15 December 2022

**SSD-35283699 – Submission**  
**Sydney Olympic Park Metro Station Over and Adjacent Station Development**

**Figure 2: Excerpts from overshadowing diagrams**

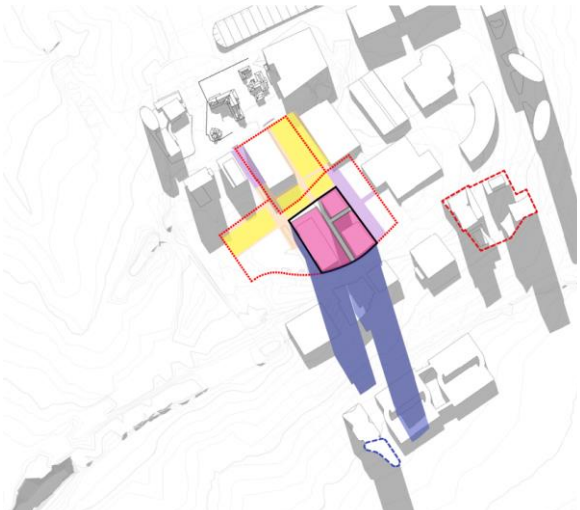
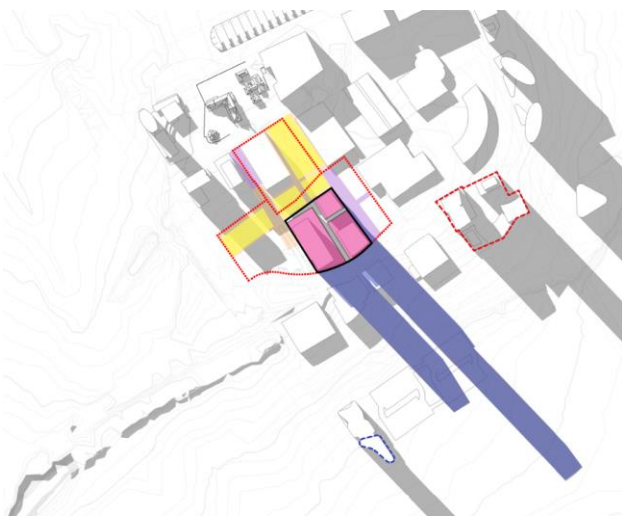
The proposed SSSA will result in significant overshadowing of Site 50 on the winter solstice from 9am through to 1pm, with vast impacts from 9am through to 12pm. This is demonstrated in the below extracts of the overshadowing diagrams submitted with the SSSA included at **Figure 2** below.

Further to the major shadow impacts caused by the proposal on Dunnet Group’s landholding at Site 50, it is evident the proposal has been designed without regard to the vision for adjacent sites that is set out in the Sydney Olympic Park Masterplan 2030 (Interim Metro Review), namely the cumulative shadow impacts on Site 50. Following the Interim Metro Review changes, the SOPA modelling and the Concept SSDA modelling indicate that two towers are to be delivered on the adjacent Site 48, located to the immediate west of the proposed Concept SSDA site, contrary to the longstanding vision of only one building being delivered on Site 48. When the proposed concept SSDA is considered together with the vision for two towers on Site 48, our landholding at Site 50 would be significantly overshadowed from 9am through to 3pm. This is clearly demonstrated in the shadow diagrams prepared by Cox Architecture that accompanied the Sydney Olympic Park Masterplan 2030 (Interim Metro Review) Response to Submissions Report (refer to **Figures 3 -5**). Further, Curzon + Partners are currently undertaking modelling on the cumulative overshadowing impacts on Site 50, and this will be submitted to the Department of Planning and Environment under a separate cover.

**Figure 3: Cumulative overshadowing impact of Sites 47 and 48 on Site 50 – 9am on winter solstice**

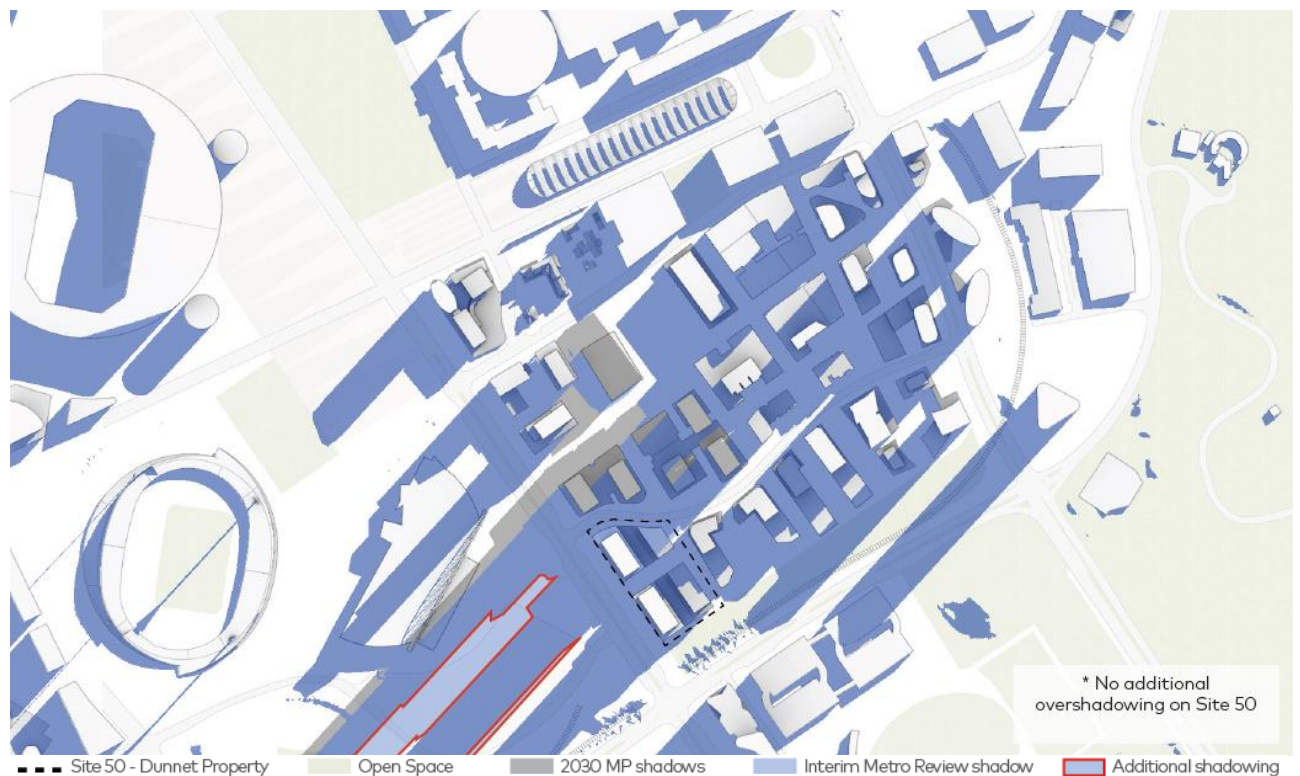
The cumulative shadow impacts caused by the proposed Concept SSDA and the future development on Site 48 will detrimentally impact the development potential of Site 50 in terms of maintaining acceptable levels of solar access to the podium and towers. This is especially harmful to the development potential of Site 50 given that the site is envisaged to be mixed use including significant components that will likely comprise a residential use. As such, given the significant all day cumulative overshadowing expected as a consequence of the Interim Metro Review of Site 47 and 48, further work is considered necessary for the Concept SSDA to mitigate the overshadowing impacts on Site 50.

As a result of the abovementioned shadow impacts that will be caused by the proposed SSDA, and the cumulative impact when also considering Site 48, it is strongly recommended that a sun access plane be adopted for Building 1 contained within the proposed Concept SSDA. The sun access plane is recommended

for this building given its proximity to the site, and the vast 63.75m width of its tower form which results in considerable shadow impacts on Site 50 that would impact its development potential.

This sun access plane should be suitably designed to minimise overshadowing of Site 50, in accordance with the recommended sun access plane designed by Curzon + Partners, which will be submitted under a separate cover. Dunnet Group recommends that the sun access plane either be included as a condition of consent for the proposed Concept SSDA on Site 47, or alternatively it could be embedded as design guidance with associated objectives in the Design Guidelines included at Appendix M of the SSDA.
